GRIDER-GHRE SUBDIVISION

APPLICATION NUMBER 7 DATE August 4, 2022

APPLICANT Grider Road - GHRE Subdivision

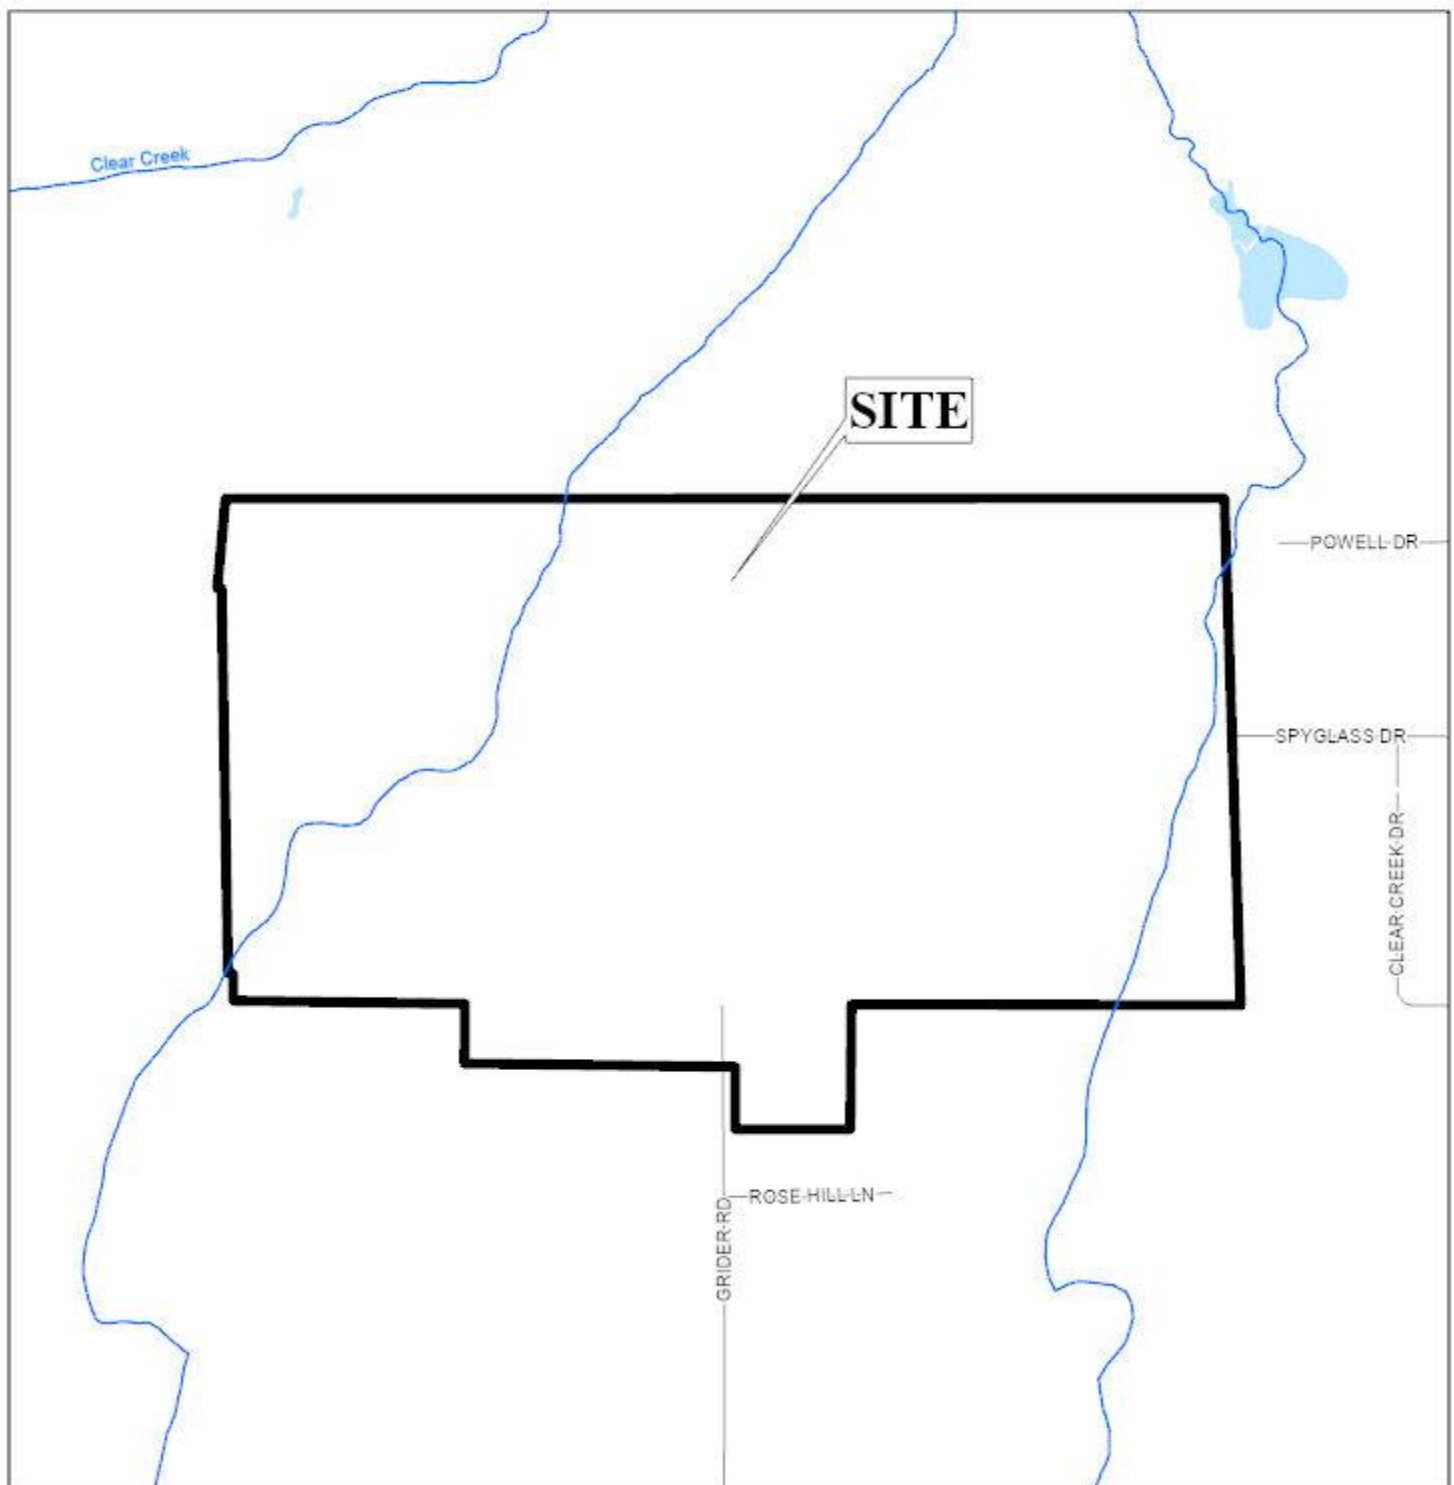
The proposed lots have frontage on Grider Road, a minor street without curb and gutter requiring a 60' right-of-way. The plat depicts a 50-foot right-of-way at this location, which reflects the existing right-of-way as recorded via previous subdivisions on the East and West sides of Grider Road. As such, no additional dedication should be required at this time.

Each lot is irregularly shaped, and the widths of Lots 2 and 3 contribute to lot width-to-depth ratios slightly greater than the 3.5 maximum allowed by Section V.D.3. of the Subdivision Regulations. Similarly designed lots within the vicinity of the subject site have been approved by the Planning Commission, therefore a waiver of Section V.D.3. may be appropriate; however, given the limited amount of street frontage for Lot 3, a note should be placed on a revised plat stating further resubdivision of Lot 3 will not be allowed until additional public street frontage is provided.

The lots meet the minimum size requirements for lots served by public water and sanitary sewer systems, but are only labeled with their sizes in acres. If approved, the Final Plat should be revised to label the size of each lot in both square feet and acres; or, the provision of a table on the Final Plat with the same information may suffice.

The 25-foot minimum building setback line is not illustrated along any portion of Grider Road, as required by Section V.D.9. of the Subdivision Regulations. If approved, the Final Plat should be revised to illustrate the required 25-foot minimum building setback line along Grider Road where each lot is at least 60 feet in width.

- 1) Revision of the Final Plat to provide the size of each lot in both square feet and acres, or provision of a table on the Final Plat with the same information;
- 2) Revision of the Final Plat to illustrate the 25-foot minimum building setback line along Grider Road where each lot is at least 60 feet in width, per Section V.D.9. of the Subdivision Regulations;
- 3) Compliance with Engineering comments: (*FINAL PLAT COMMENTS (should be addressed prior to submitting the FINAL PLAT for review and/or signature by the City Engineer): A) Provide all of the required information on the SUBDIVISION PLAT (i.e. signature blocks,*

SITE PLAN

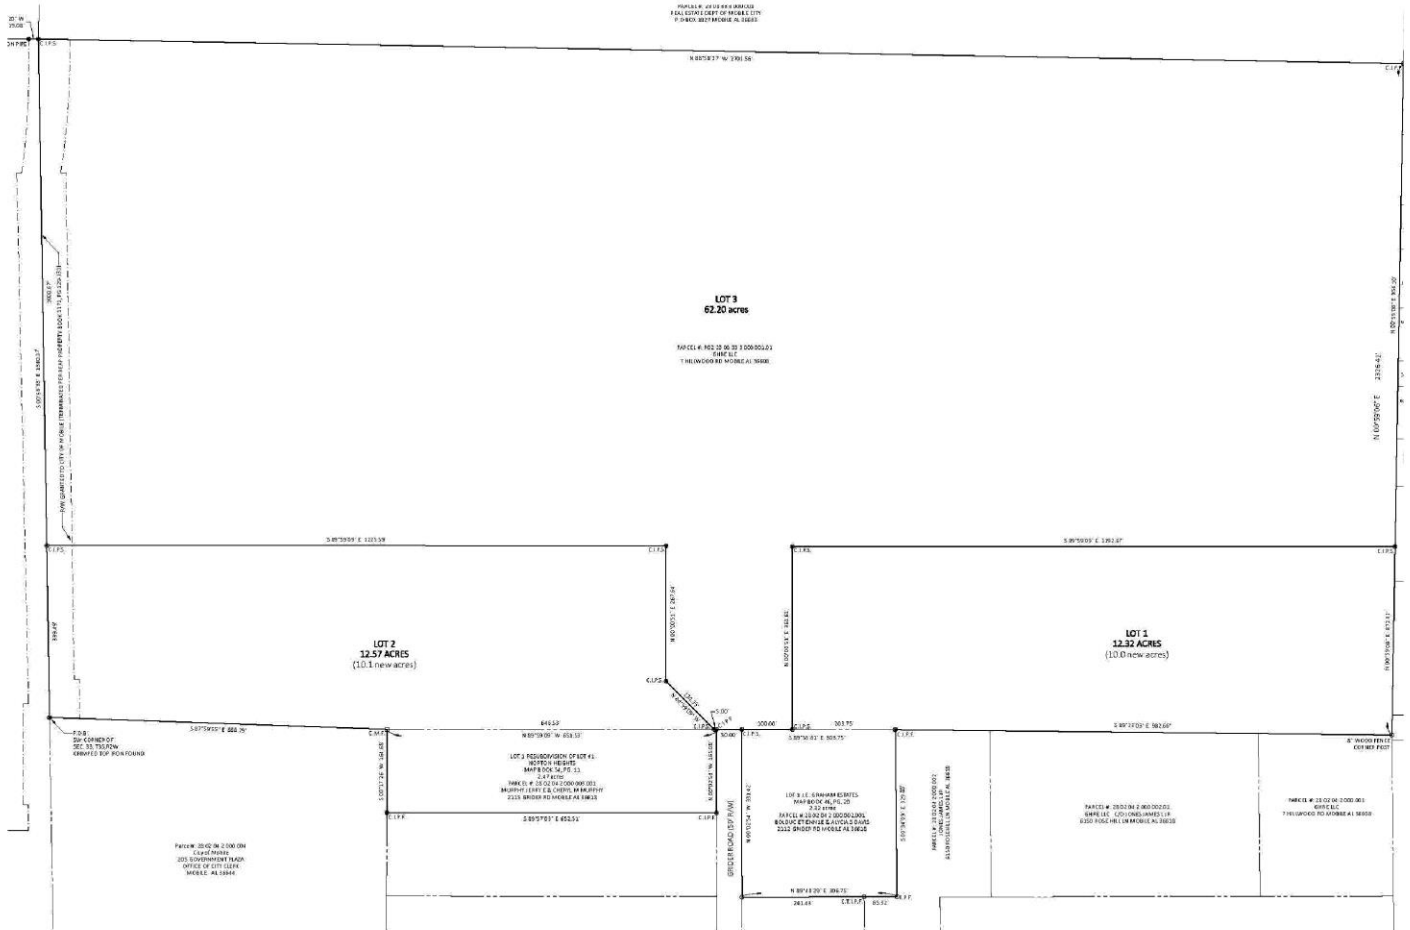
- B. Update the PLAT to reflect the ROW dedication shown in RP book 1171 page 129-131 or provide recording information for the ROW Vacation.
- C. Dedicate ROW for a turnaround at the north end of Grider Road.

- F. Add a note to the SUBDIVISION PLAT stating that as shown on the 1984 aerial photo (FLIGHT 20 - #66) LOTS 1, 2, and 3 will receive historical credit of existing (1984) impervious area towards stormwater detention requirement per Mobile City Code, Chapter 17, Storm Water Management and Flood Control) as follows: LOT 1 – 2,500 sf, LOT 2 – NONE, and LOT 3 - NONE.
